Staff Report

To: BOZAR
From: Jessie Earley, Town Planner III
Meeting Date: DRC, January 21, 2025 (TUESDAY)
RE: Liebl (226 Sopris Avenue), Preliminary Review

PROJECT TITLE: Liebl (226 Sopris Avenue)

Proposed Site Plan

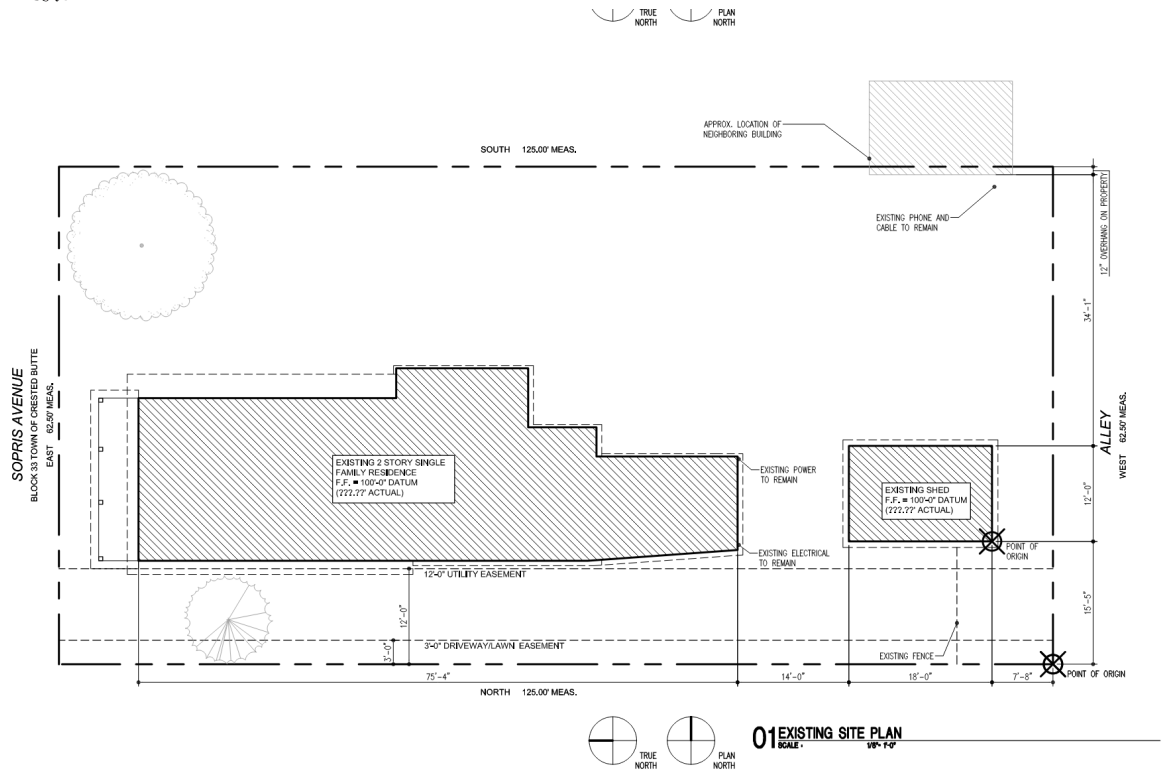
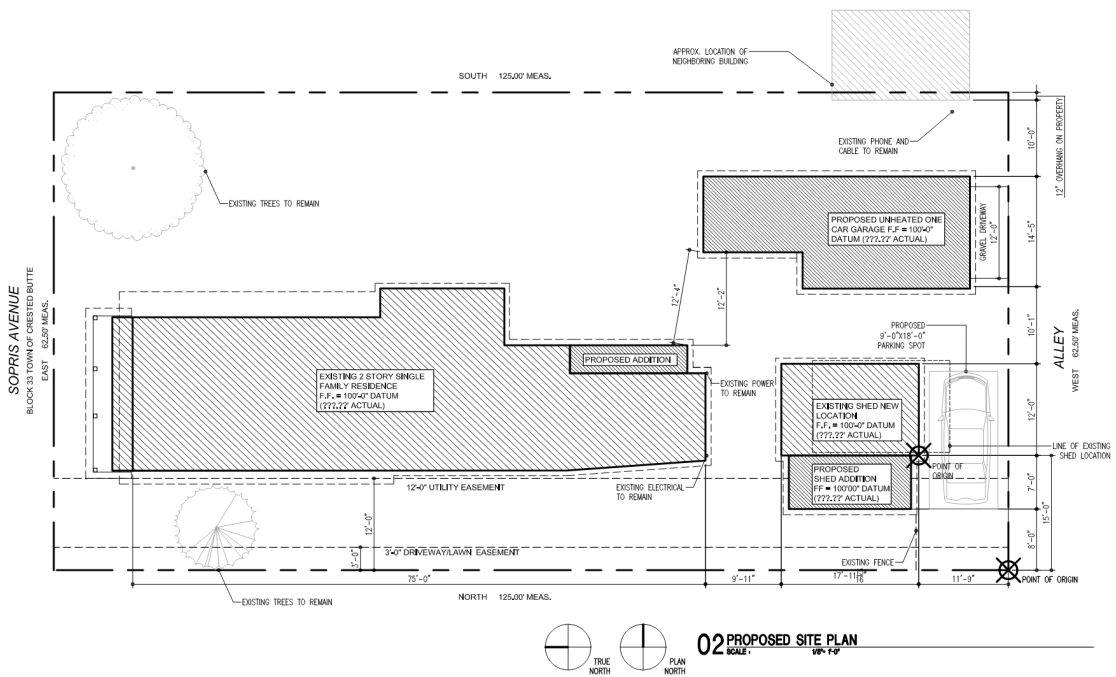
GL	Staff Analysis	DRC Recommendation
Topography	Topography is not included, but should be. This information is not anticipated to impact FAR or height requirement.

2.8 Drainage	Drainage arrows have not been shown and must be.	
Easements	There area existing easements on the west portion of the lot, which includes a 3' driveway easement and 12' utility easement. There is a letter from the property owner to the east expressing support for the addition.	NA

2.16 e Pervious materials	Walkways and parking have not been included on the proposed site plan and must be.	
2.28 e & f Parking substrate	Parking spaces are noted on the site plan. Substrate must also be called out.

been included and should be. If existing fixtures do not meet requirements, they will be required to be upgraded as part of the work to be done.	
Solar	NA	
Utilities	Existing and proposed wet and dry utilities must be noted on the plan. Rights of way (alley and Sopris Avenue) must be shown to scale on the site plans.	
2.7 Snow Storage	Snow storage must be depicted on the plan and correspond to the areas to be plowed.	
2.27 Fences	An existing fence is on the south. Confirmation is needed if there will be a new fence proposed.

Plan view (east)-Primary Building - proposed

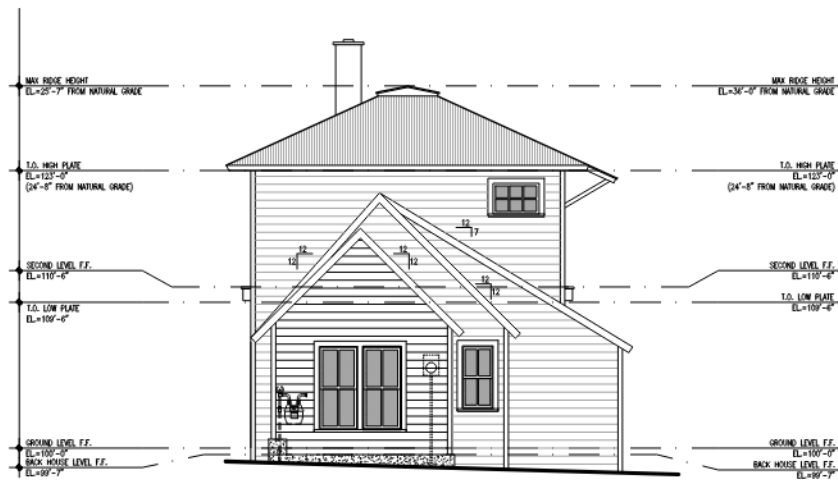
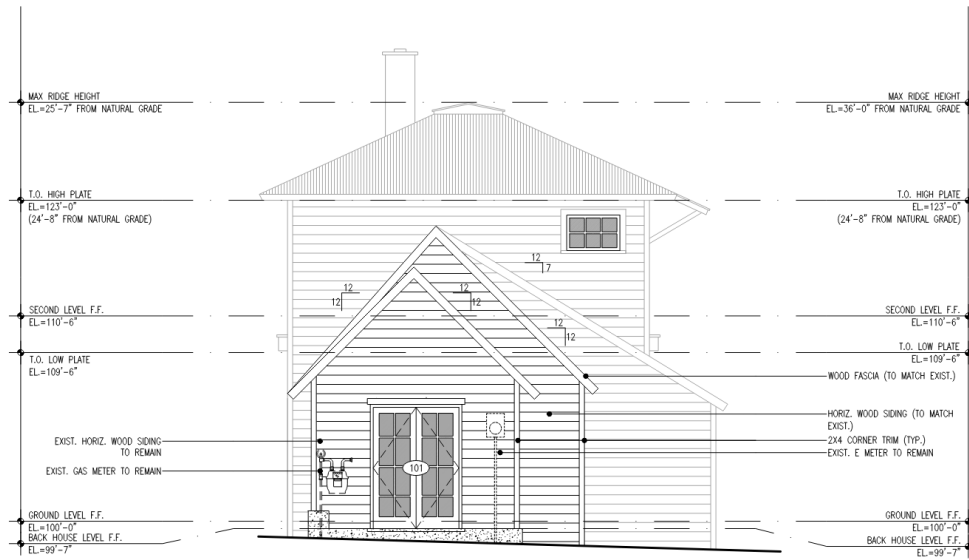
GL	Staff Analysis	DRC Recommendation
3.17 Additions to historic buildings	<p>Primary: The addition to the primary building fills in a small area on the southeast corner. A 3D rendering showing the existing and proposed area would be helpful to show the change.</p> <p>Accessory: The addition to the accessory building steps down from the main ridge and also from the north and south. A change in material would be encouraged.</p>	
3.18 a Stepping down additions	<p>Primary: The addition will continue the roof pitch that is existing in the southwest corner of the building 12:12.</p> <p>Accessory: The addition on the west steps down 4'3" from the main ridge. Discussion is encouraged to determine if the addition is subordinate.</p>	
3.18 b/ 3.36 Connector	This GL suggests a connector. In both

WINDOW SCHEDULE

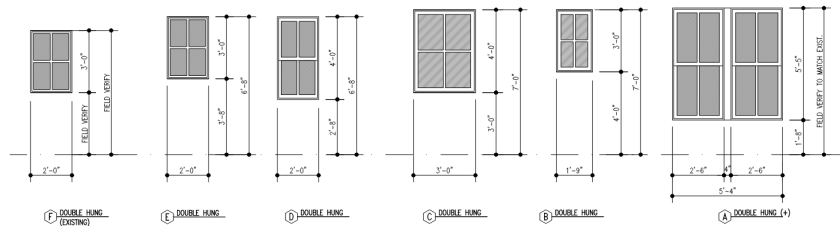
4.54 Vertical emphasis	<p>Windows are shown as a two over two double hung style window to match existing windows.</p> <p>A window and door schedule has been provided.</p> <p>Casement windows are noted. Per GL 4.54, these windows are reserved on historic buildings for egress only. Non-egress windows should be double hung windows. All windows must provide simulated divided light for new windows.</p>

4.56 Window material	<p>Aluminum clad windows are noted on the materials list, color confirmation needed.</p> <p><u>Primary:</u> If all windows exist as wood, they would need to remain as wood. Simulated divided lights are required, which are noted on the materials list.</p> <p><u>Accessory:</u> All windows exist as wood in the AB and any new windows must be wood.</p>

4.58 Groupings of 2 or more windows	Primary: Support Accessory: There is trim provided between windows on the south and west. These windows cannot be mullied.	
4.59 Window and door trim	Trim is proposed as 2"x4". Support.	
4.60 Divided lights	Simulated divided lights are required.

South – proposed rear door (primary building)

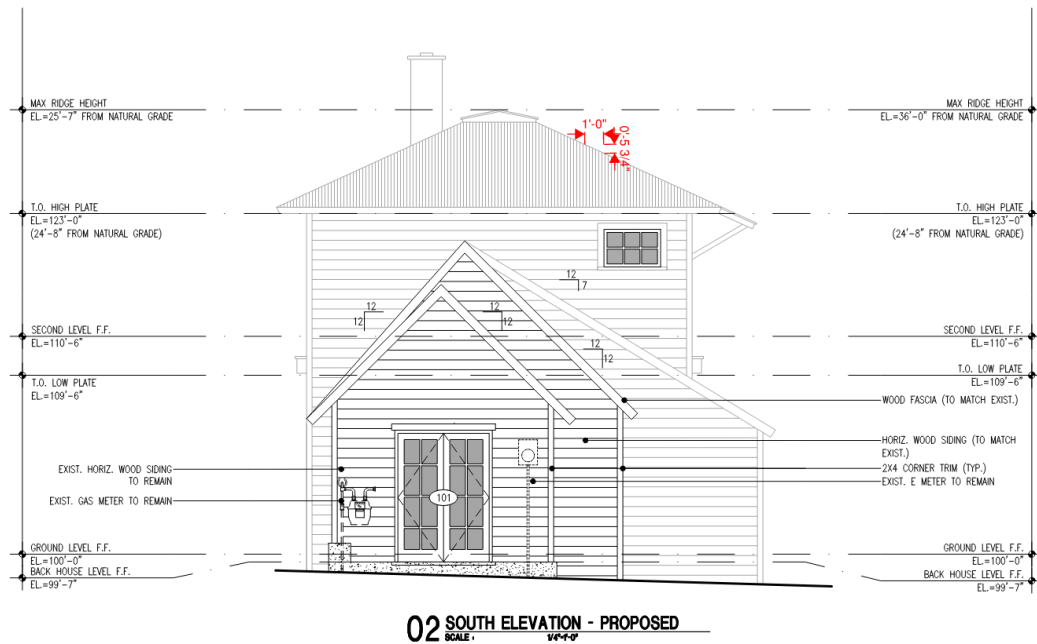
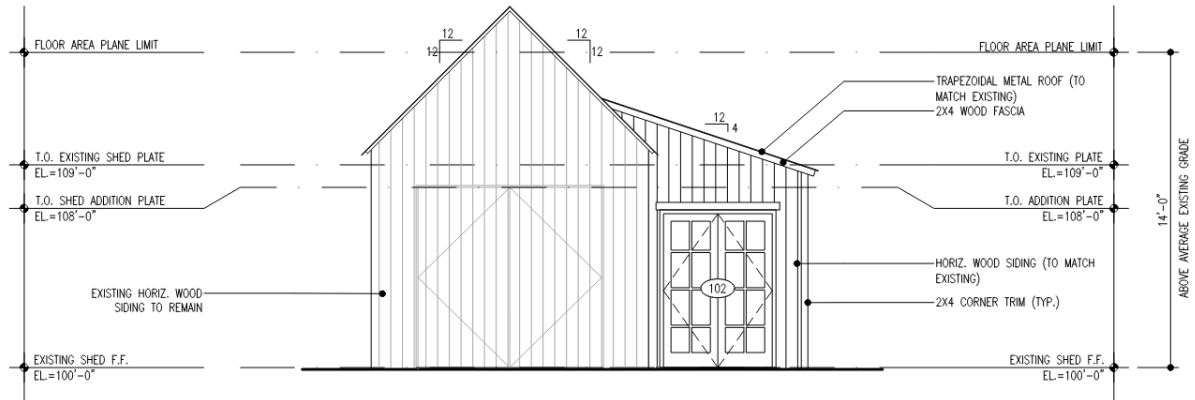
GL	Staff Analysis	DRC Recommendation
4.64 Primary door	The primary door will continue to face Sopris Avenue. Support.	
4.65 Primary door	Primary: This door is to remain. Support. Accessory: The primary barn style door on the north is to remain and be rehabilitated.	
4.66/3.58 Secondary doors	There are full light, aluminum clad French doors proposed on the south elevation of the primary building. This proposal appears to be consistent with GL 4.66 b. There is another set of full light, aluminum clad French doors proposed on the north elevation of the accessory building. This French door is not highly visible from the street but does appear tight on this small module. A single

door might appear more in historic context.	
--	---	--

There is a new wood French door with divided lights proposed on the south. The door plan states that this door will be a metal clad door. Confirmation of the door materials is needed.

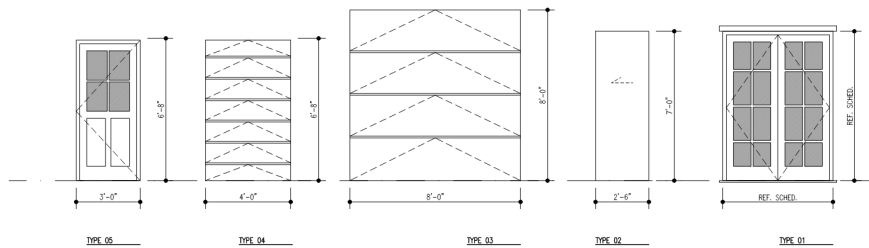
GL	Staff Analysis	DRC Recommendation
4.66 Secondary Doors	There is a ½ light aluminum clad person door on the north, color must be confirmed. Support	
4.69, 4.90 Garage doors	There is a garage door proposed on the south elevation and a smaller garage door proposed on the west elevation. Both are noted as aluminum doors, but must be clad with wood.

Proposed Alley view

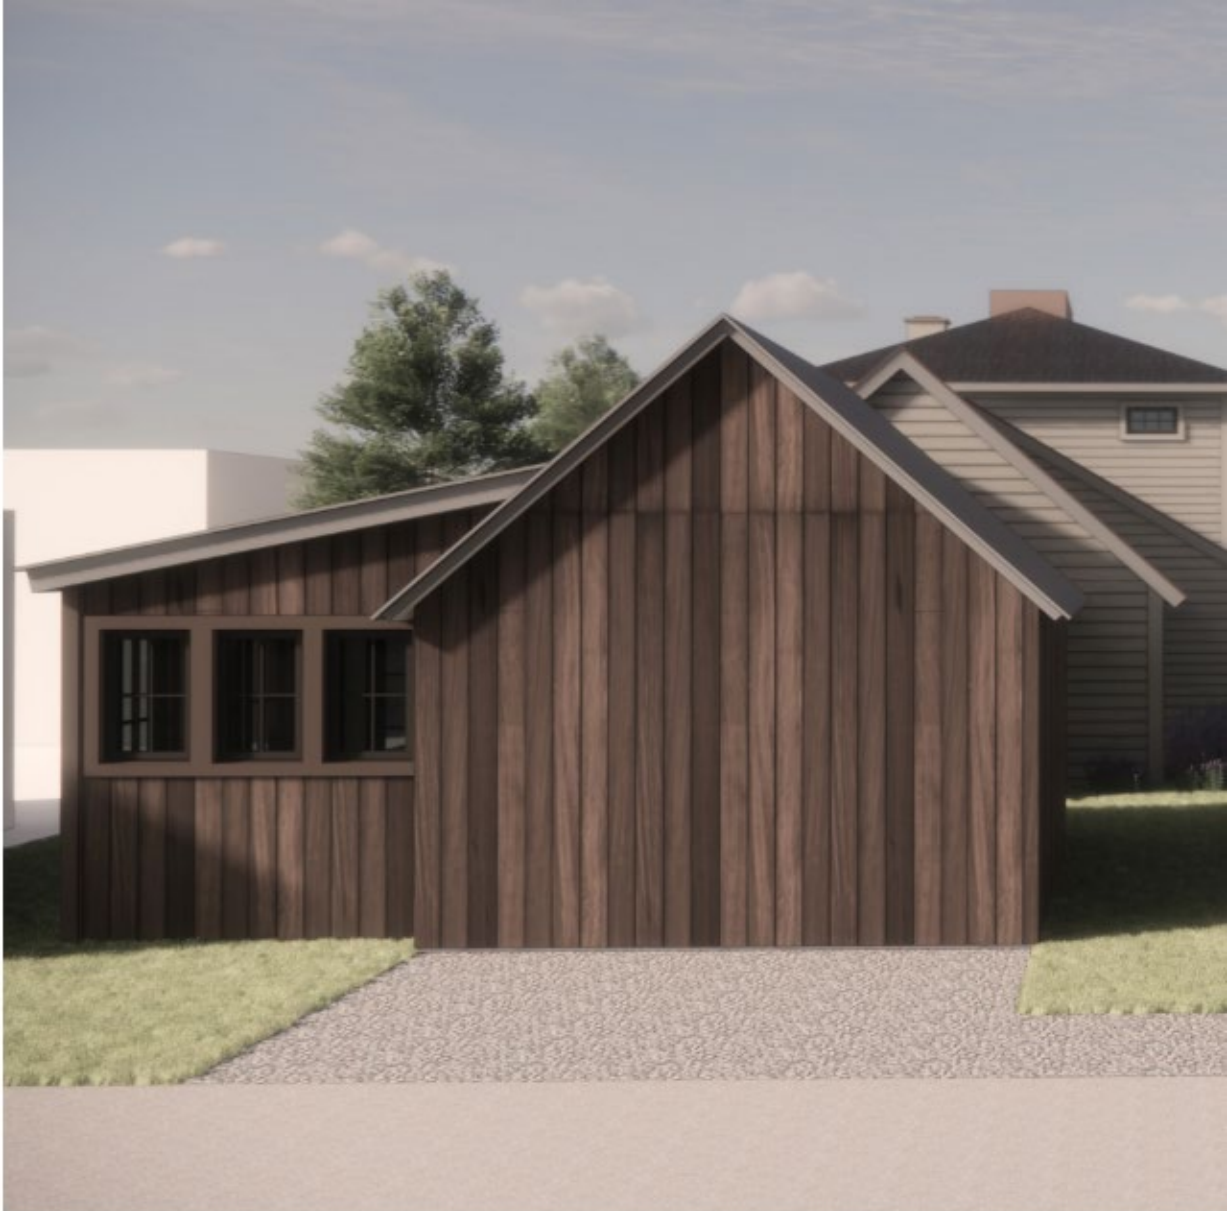
4.72 Eaves/overhangs	Met.	
4.75 Exterior materials	<u>Primary:</u> Met <u>Accessory:</u> The proposed siding meets the intents of the GL. However, more definition is needed for the addition to the accessory to help define this historic portion versus the new portion.

3.61 Roofing materials	The materials proposed are supported by the GL. More discussion is needed to ensure that the historic material will remain in place. Also, the rusted material has generally not been supported. Naturally weathered material is supported on new portions of the building.

4.80 a foundation treatment	The proposed 18” of metal is consistent with the GL. However, confirmation is needed as to where the material will be sourced from, as noted it says the primary building, but this material is to remain.

Proposed Alley view

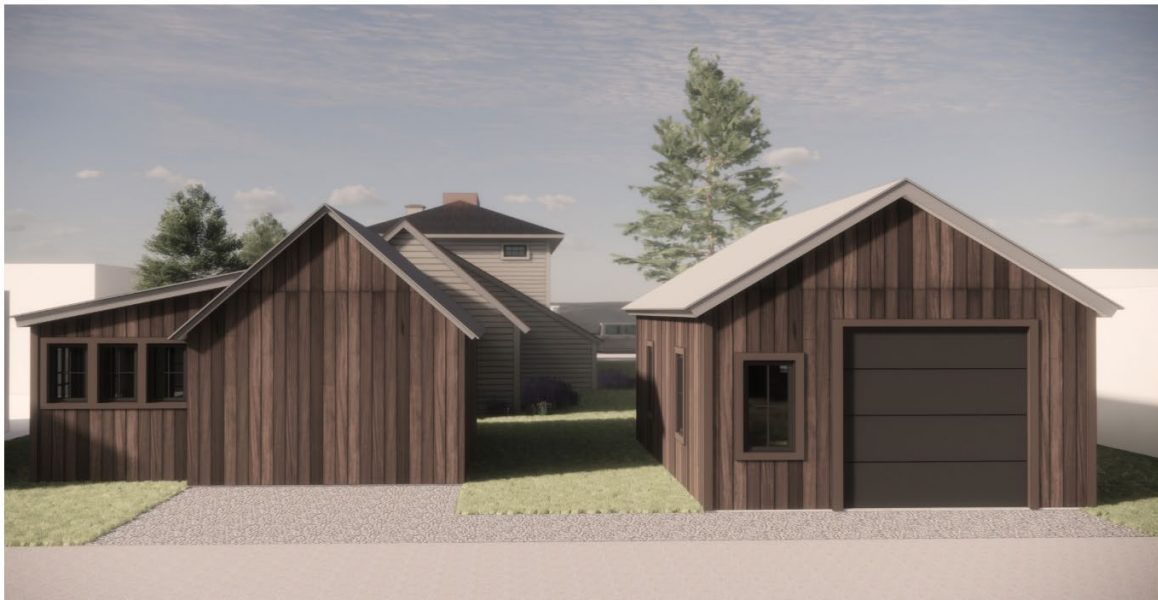
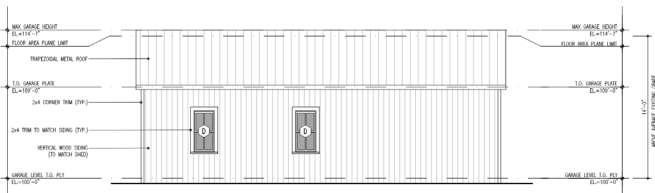
The proposed south cold accessory building is an 22'5"x15'2" gabled building with a smaller gable module to the north 13'x10'5". The accessory has a 8:12 pitch. This must be a cold building due to the size, as proposed.

GL	Staff Analysis	DRC Recommendation
4.84 Smaller in size	The proposed building is smaller in scale than the primary building, as requested by the GL.	
4.85/5.94 Rear of the site	The proposed building is located at the rear (south) of the lot. Support.	
4.86 Vary appearance	As seen in the 3D models, this building is proposed to mimic the existing historic building to the west. The form of the building is simple and supported. However, the material should be varied from the building to the west.	
4.89 d. porches	NA	NA

GL	Staff Analysis	DRC Recommendation
4.53; 4.89 AB fenestration	<p>There are two single windows on the north, east and west elevations. The south elevation has one window.</p> <p>There are fewer windows than the primary building. The window to wall ratio for the proposed north elevation is 17.6%. This percentage is more relational to primary building. Staff would suggest reduction in the glazing for this elevation.</p>
